UNITED STATES PATENT AND TRADEMARK OFFICE

Office Action Summary

10/538,968

DETAILED ACTION

Fig.11

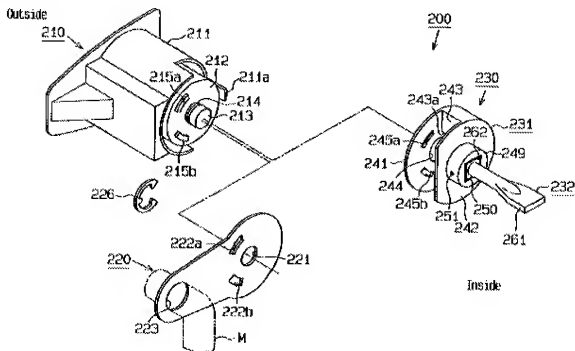
4. Regarding claim 1, Katagiri shows an actuating device for a lock in a door or hatch of a motor vehicle (column 1, line 8), with a lock cylinder (200), which has a lock (column 9, lines 57-58) located a certain axial distance away and a one-piece shaft (232) extending between the lock cylinder and the lock; which shaft transmits a force to the lock when the lock cylinder is rotated; the shaft is flexible in an axial direction of the

shaft to compensate for a radial offset between the axis of the lock cylinder and the lock (column 12, lines 15-25) and wherein a driver (261) for actuating the lock and/or a connection (230) for the lock cylinder is formed integrally on the shaft. See the Katagiri device below.

6. Regarding claim 2, Katagiri in view of Brahler, Katagiri shows the driver (261) has the form of a paddle.

7. Regarding claim 3, Katagiri in view of Brahler, Katagiri shows the connection (230), wherein an overload element (free wheel type cylinder; column 13, lines 4-15) is integrated into the connection (column 13, lines 4-15), the overload element, when the lock cylinder is actuated as normal by the key, ensures a nonrotatable connection between the cylinder core and the connection at the outer end of the shaft, but also wherein, when the lock cylinder is actuated forcibly as a result of which a specific torque limit is exceeded, the overload element lets the cylinder core and the driver for

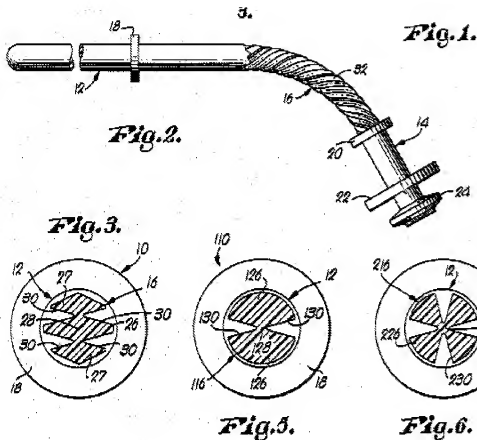
5. Although Katagiri shows applicant's basic inventive concept of an actuation device for a lock in a motor vehicle, Katagiri fails to show a shaft which submits a torque having the claimed notches, but Brahler shows this to be well known in the art. Brahler shows a flexible drive shaft (10), usable in any application (column 4, lines 40-48) for transmitting torque (column 4, line 31) wherein the one-piece shaft is made of flexible material (see claim 1) and has a family of notches (30) extending transversely to the

axis of the shaft; the notches are recessed in pairs (see figure 3) into the shaft from diametrically opposing sides, the notches each having two flanks (each side of the notch); wherein when the shaft is stretched out straight, the two flanks of the notches are "essentially" parallel to each other and extend radially with respect to the axis of the shaft; wherein the notch pairs leave a web (28) in the shaft between the flanks the web is located on the axis of the shaft and extends essentially across the entire diameter of the shaft; the web produces flex points(see bending at 32 in figure 2), at which, when bending load is exerted on the shaft, the two flanks of the notch pairs can swing toward or away from each other (the flanks can bend toward or away from each other depending on the bending of the shaft); wherein intermediate axial pieces (26, 27), extending in the axial direction of the shaft and with the full cross section of the shaft, remain between successive pairs of diametrically opposing notches. It would have been obvious to one of ordinary skill in the art to replace the shaft portion of Katagiri using the flexible shaft of Brahler to provide enhanced flexibility. Replacing one flexible shaft with another flexible shaft is considered to be within the level of ordinary skill in the art. See the Brahler device below.

1. Applicant's arguments filed 2/1/10 have been fully considered but they are not persuasive. Regarding the argument relative to feature E, the examiner points out that the E portion of the claim only requires a flexible material and a family of notches transverse to the axis. Brahler teaches this limitation as shown in the figures above. Please note that "a continuously changing cross-section and a full cross-section" are being argued but are not claimed. Regarding feature L, merely stating that Brahler does not have the limitation does not constitute a valid argument. Further explanation and reasoning should be provided as the examiner believes Brahler does teach this feature as argument above. Regarding feature G and the term "essentially parallel", Brahler shows flanks that extend at different including some radial and some parallel to each other. Please note the different shapes of Brahler disclosed in the figures. Regarding the features to H and I, including the web, Brahler shows the web as identified above (between the flanks).
